Docket Item #13
BAR CASE# 2005-0165

BAR Meeting
January 18, 2006

ISSUE: Details and materials for a 65-unit condominium building at 1514-1518, 1600-1602 King Street & 1602 Dechantal Street

APPLICANT: DSF-Long King Street 1, LLC.

Figure 4 Proposed King Street elevation

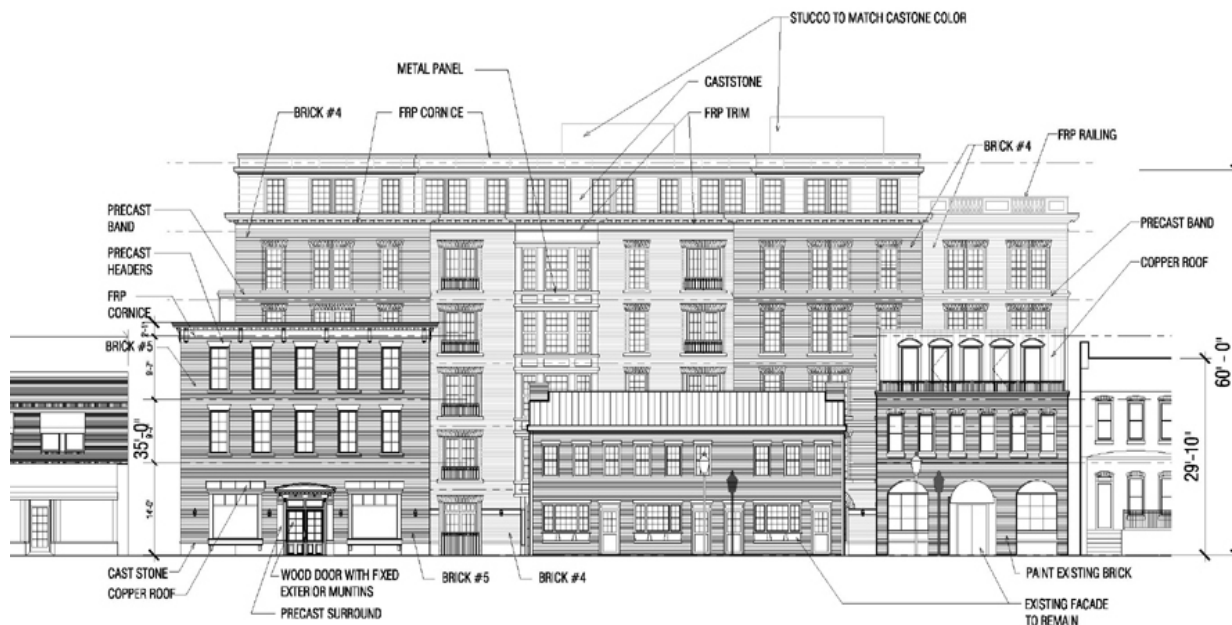
The Board previously requested that the large show windows flanking the front entrance of this new retail portion be restudied. The revised design replaces multiple lights with a large plate glass window topped with a transom-like strip of four lights. The show windows project slightly from the face of the building and have narrow windows on each side. The window sash and frame is an aluminum storefront system. The trim is FRP. The roof is copper.

BAR Staff believes the applicant has been responsive to the Board's previous comments and finds the project acceptable. The revised design of the new building is more harmonious than in the previous iteration, allowing it to function as a background building. The retail arm at 1514-1518 King Street and preserved facade at 1600-1602 King Street relate well to the neighboring, small scale buildings along King Street. The detailing of the new construction is simple yet compatible in material and design with the nearby historic district and the 100 Year Old buildings. Staff has only minor comments regarding changes to the scale of the exterior light fixtures to better accentuate the main entrances. As noted above, the detailing of the cast stone which will clad the sixth story and form the base of the building has not yet been worked out. The size of the cast stone units, the extent of variety within the units, coursing patterns, reveals and the like will significantly impact the overall appearance of the building. Therefore, Staff believes it is important that Staff review and approve the final detailing of the cast stone. Lastly, to ensure that the materials used in the construction remain consistent with those approved by the Board, it is recommended that Staff review and approve the on-site materials mock-up.

1. That the light fixtures on the front facade of the retail arm at 1514-1518 King Street be larger in scale and be limited to either side of the entrance;

Figure 6 Proposed East elevation

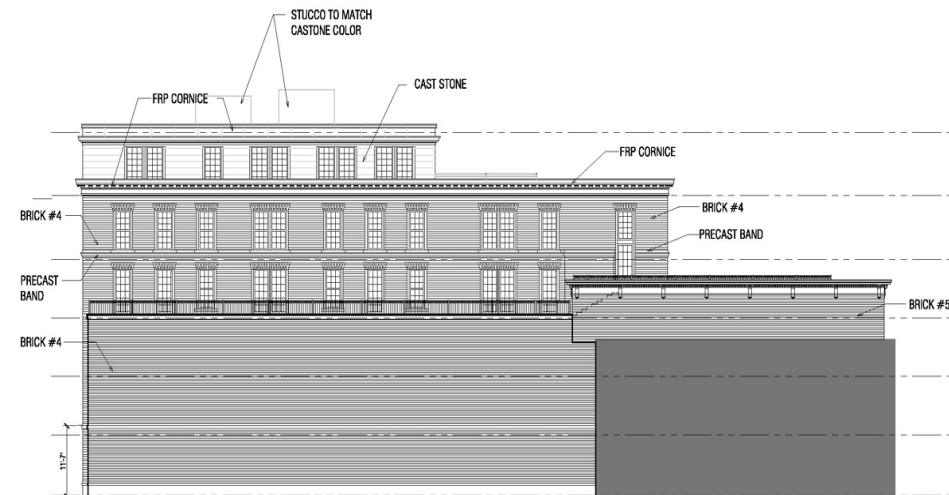
2. That the light fixtures at the main entrance of the condominium building on the north elevation be larger in scale;
3. That Staff review and approve the detailing of the cast stone;
